Attachment A Facility Comments for Question #78

Beaver Valley Unit 2 NRC Written Exam (2LOT7) SRO ONLY

Attachment A Facility Comments for Question # 90

Figure 3.4.16-1 (Page 1 of 1) Reactor Coolant DOSE EQUIVALENT I-131 Specific Activity Limit Versus Percent of RATED THERMAL POWER

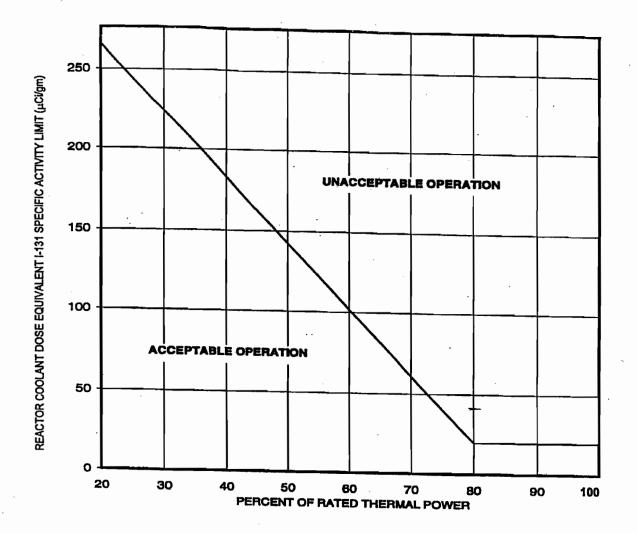
The initial power level for the question was 95% with a small fuel element failure and a Dose equivalent I-131 sample of 40µCi/gm. The SRO applicants were given a copy of Tech Spec 3.4.16 RCS Specific Activity and Tech Spec Figure 3.4.16-1 (Attachments 78-1 and 78-2). The applicants were asked to identify the Tech Spec required action and the bases for the action. LCO 3.4.16 Condition A is NOT met since the Dose equivalent I-131 sample of 40µCi/gm is greater than 0.35µCi/gm. Condition A has two required actions, A.1 Verify Dose equivalent I-131 within the acceptable region of Tech Spec Figure 3.4.16-1 AND A.2 Restore Dose equivalent I-131 to within limit within 48 hours. On Tech Spec Figure 3.4.16-1 the Dose equivalent I-131 of 40µCi/gm is NOT within the acceptable region. LCO 3.4.16 Condition C is also NOT met and the required action is to be in Mode 3 with T_{avg} less than 500 °F within the next 6 hours. This was the answer key answer, choice B along with the correct bases. The intent of the question was to identify this required action.

However, IAW ITS section 1.3 "Completion Times" Pg 1.3-1 and Pg 1.3-11 (Attachments 78-3 and 78-4) when multiple conditions apply to a single LCO all action times must be tracked and monitored from time of discovery to meet said condition. Additionally, ITS Section 1.2 "Logical Connectors" page 1.2-1 (Attachment 78-5) states "both actions must be completed as long as the condition applies". Therefore LCO 3.4.16 Required Action A.2, Restore Dose equivalent I-131 to within limit within 48 hours is still a required action even though LCO 3.4.16 Condition C is more restrictive.

Restore Dose equivalent I-131 to within limit within 48 hours was choice D with the same bases as choice B.

Based on this information, the facility recommends accepting D as an alternate acceptable answer.

USST Inputs to Generator Protection -Secondary (backup)

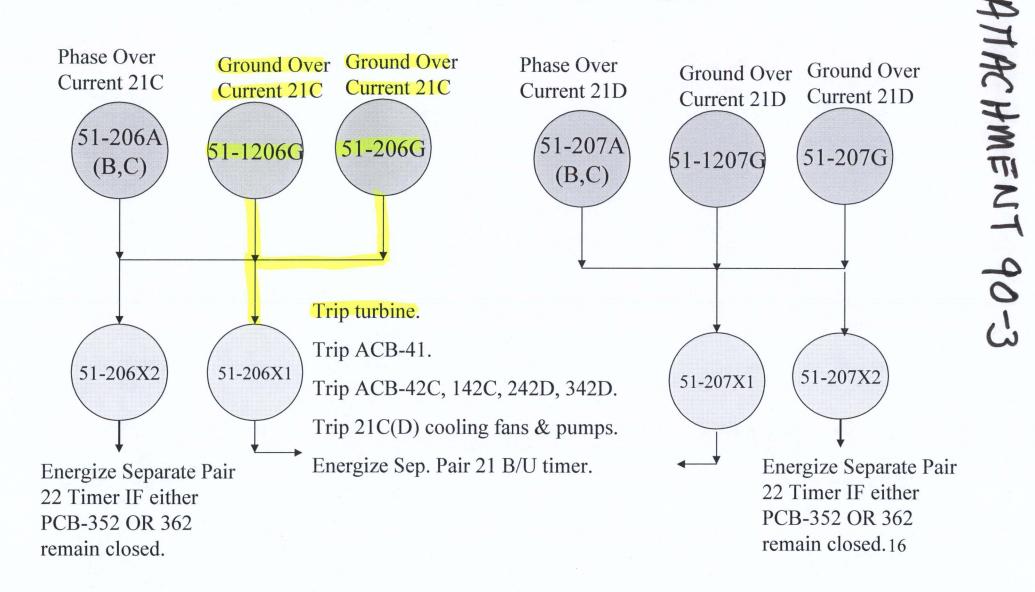
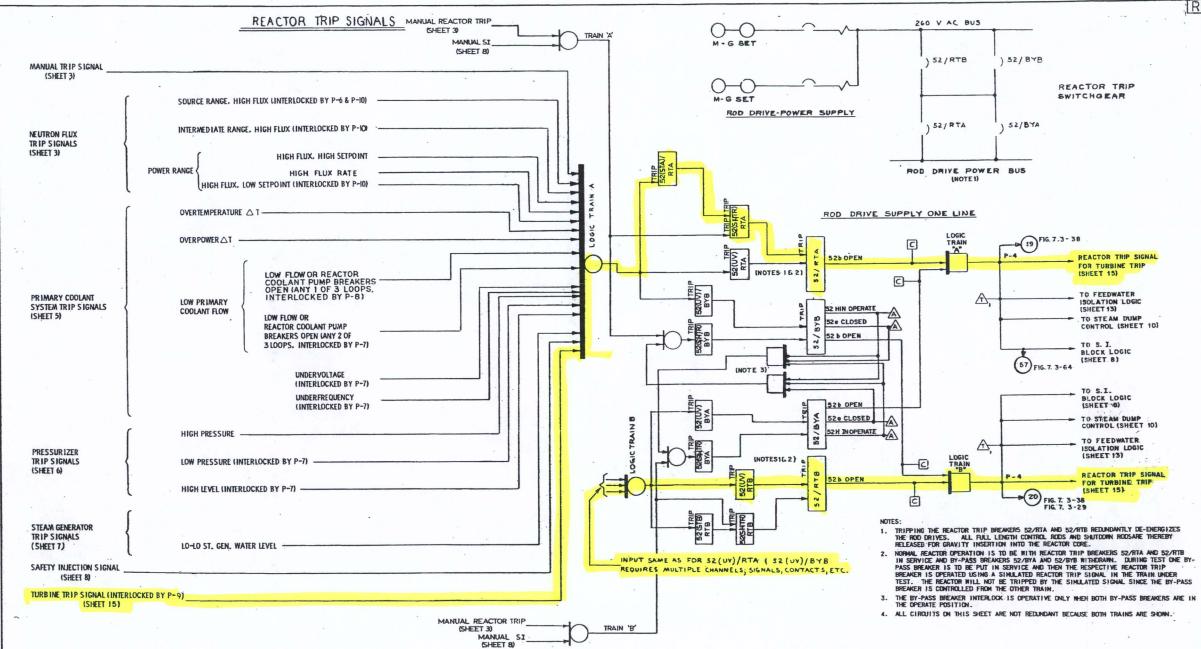
However, if annunciator A5-8C, "US SERV TRMR 2C OVERCURRENT GEN TRIP is received, initiating device 251-206G is activated (Attachment 90-2). This will initiate a turbine trip (Attachment 90-3), which will initiate a reactor trip (Attachment 90-4) and the EOP network will be entered.

Based on this information, the facility recommends deleting this question from the exam.
